# Groundwater Transfer Review Summary Form

Transfer/PA # T- 14416

Application: T-14416

Applicant Name: Westwood Farms, Inc. ATTN John Coleman

**T 14116**  
**Westwood Farms, Inc.**

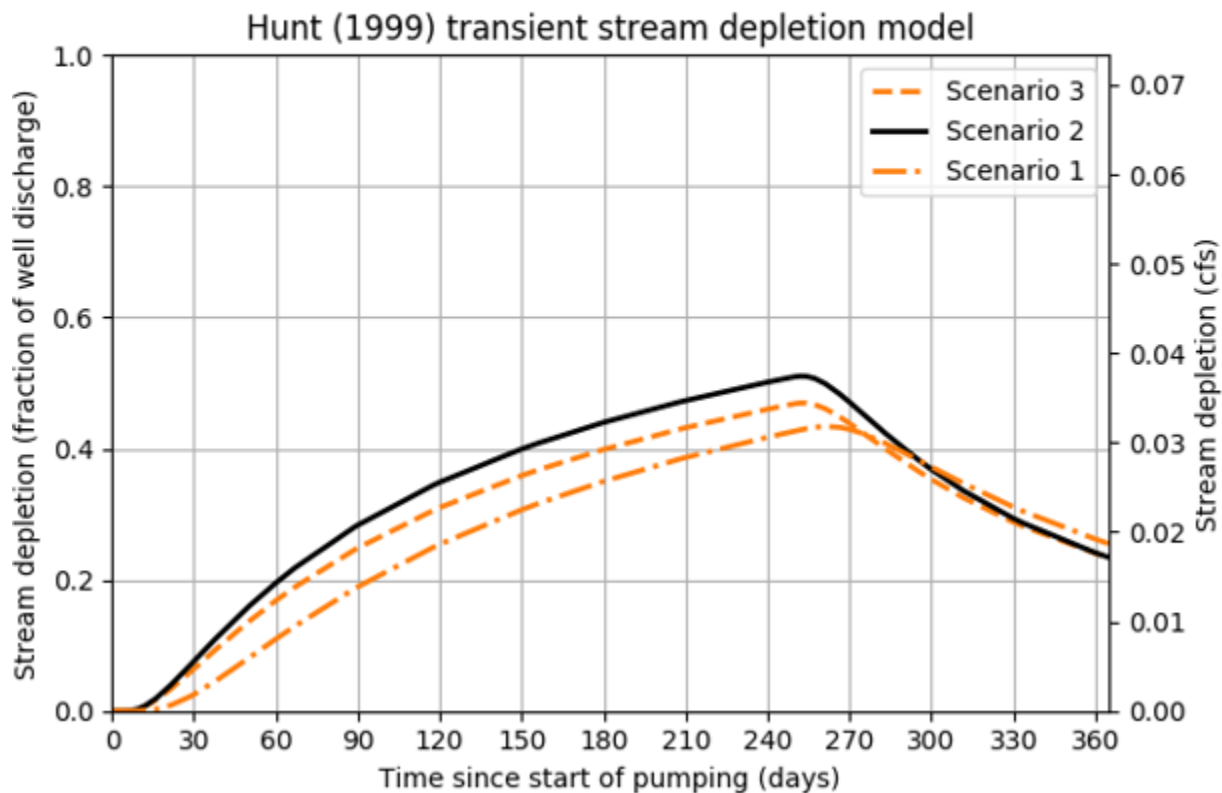
4. a) Will this proposed change, at its maximum allowed rate of use, likely result in an increase in interference with **another ground water right**?  
☐ Yes ☒ No Comments: The authorized POA (MARI 4799) is closer to the nearest groundwater user than the proposed APOA (MARI 4811); it is anticipated that the proposed transfer will result in a decrease in interference with other groundwater users.

5. a) Will this proposed change, at its maximum allowed rate of use, likely result in an increase in interference with **another surface water source**?  
☒ Yes ☐ No Comments: The proposed APOA (MARI 4811) is closer to Mission Lake and the Willamette River than the authorized POA (MARI 4799).

**APOA/POA 2 (MARI 4811)-Mission Lake**

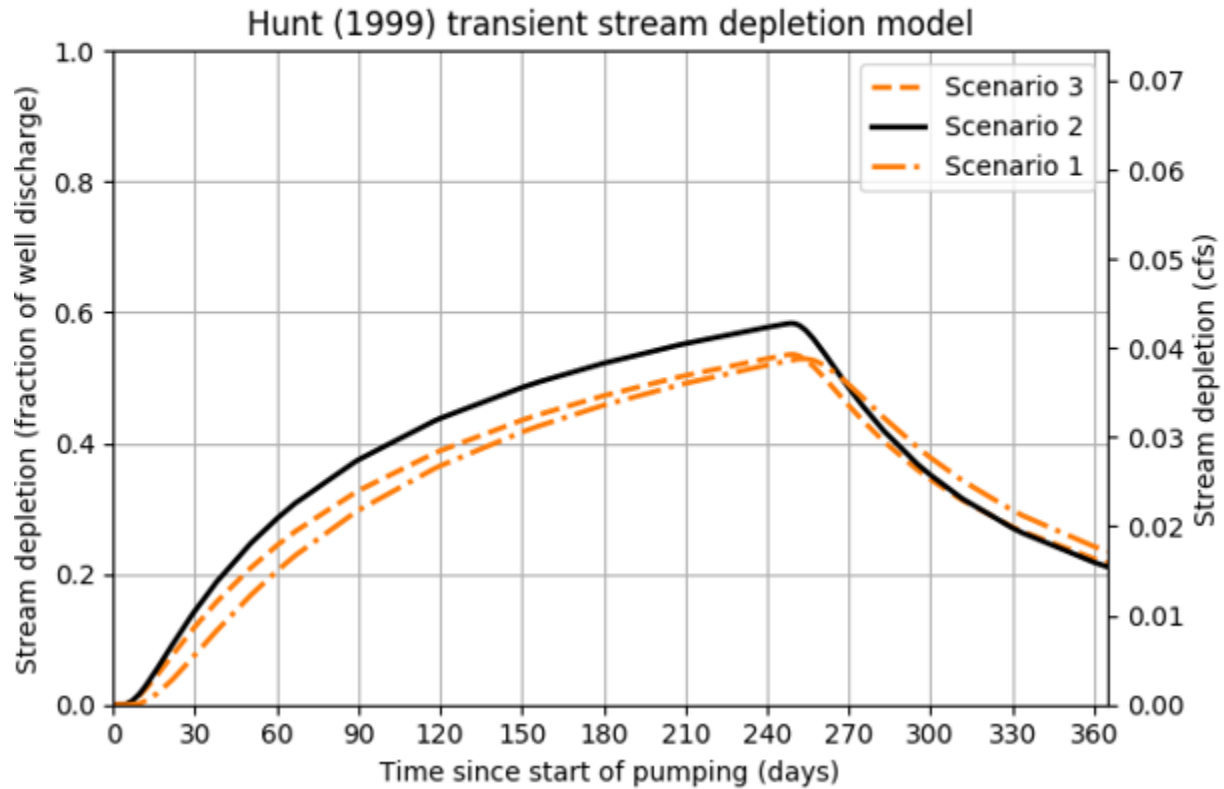
- b) If yes, at its maximum allowed rate of use, what is the expected change in degree of interference with any **surface water sources** resulting from the proposed change?  
Stream: Mission Lake ☒ Minimal ☐ Significant  
Stream: Willamette River ☒ Minimal ☐ Significant  
Provide context for minimal/significant impact: The expected increase in depletions to Mission Lake was assessed using the Hunt (1999) analytical model for stream depletion due to pumping in an unconfined aquifer (see attached Stream Depletion Analyses). Results indicate that stream depletions to Mission Lake and the Willamette River due to pumping could likely increase by 8 percent and 6 percent, respectively, of the average rate of withdrawal after 245 days of continuous pumping (i.e. the end of the irrigation season) as a result of the proposed change. Assuming that proposed APOA (MARI 4811) were to pump the prorated duty under GR-951 (35.625 AF) over the full 245-day irrigation season, the average increase in the rate of withdrawal would be ~0.073 cfs; therefore, the proposed change could result in an additional ~0.01 cfs of depletions to Mission Lake and 0% to the Willamette River by the end of the irrigation season. For comparison, Watershed ID# 182 WILLAMETTE R > COLUMBIA R – AB MOLALLA R, which encompasses Mission Lake and this section of the Willamette River, is estimated to have ~680 cfs of Net Water Available in August (the month with the lowest expected flow annually) at the 80 percent Exceedance Level (see attached Water Availability Analysis). Therefore, the change in degree of interference with Mission Lake and the Willamette River resulting from the proposed change is expected to be minimal.
